Our ref
DS_CC_PPE-121779

Date
23 April 2021

Level 1 Capacity Check Enquiry: Pfizer, 32 New Lane, Havant, Hampshire, PO9 2NG.

Foul Water

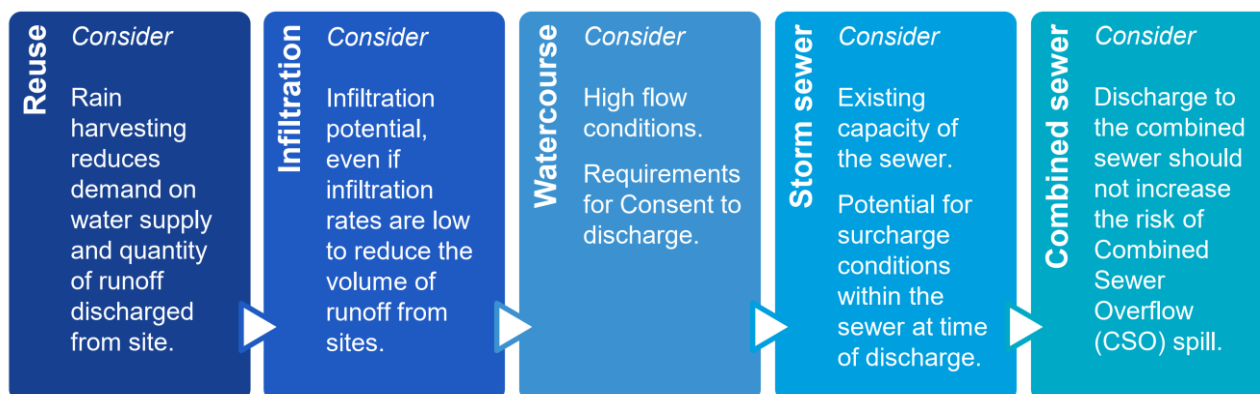
The enquiry has been reassessed to determine the capacity available for 0.41 l/s at manhole reference SU72073101.

There is currently adequate capacity in the local sewerage network to accommodate a foul flow of **0.41 l/s** for the above development at manhole reference SU72073101. Please note that no surface water flows (existing or proposed) can be accommodated within the existing foul sewerage system unless agreed by the Lead Local Flood Authority in consultation with Southern Water, after the hierarchy Part H3 of Building Regulations has been complied with.
